Addendum

Iowa Department of Transportation Office of Contracts Date of Letting: April 19, 2011 Date of Addendum: April 8, 2011

B.O.	Proposal ID	Proposal Work Type	County	Project Number	Addendum
111	66-C066-053	PCC OVERLAY - UNBONDED	MITCHELL	STP-S-C066(53)5E-66 FM-C066(54)55-66 L-LPPCC-173-66 L-LPPCC-273-66 L-LPPCC-473-66 L-LPPCC-573-66	19apr111.a02

Make the following change to project L-LPPCC-1--73-66, sheet B.01:

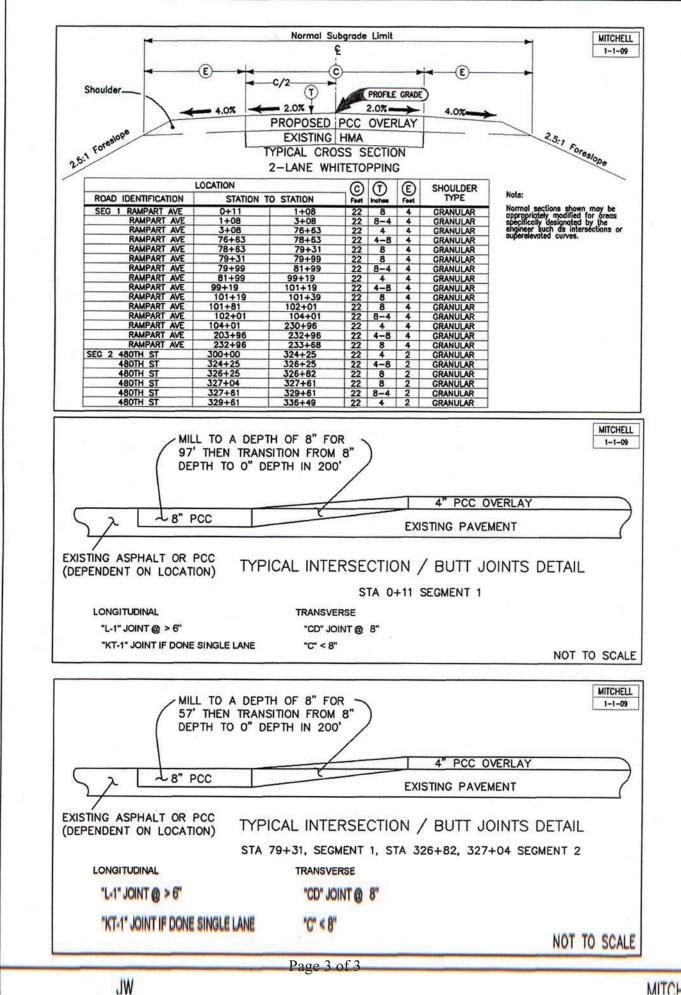
Replace the three typicals on the left portion of the sheet with the attached three typicals.
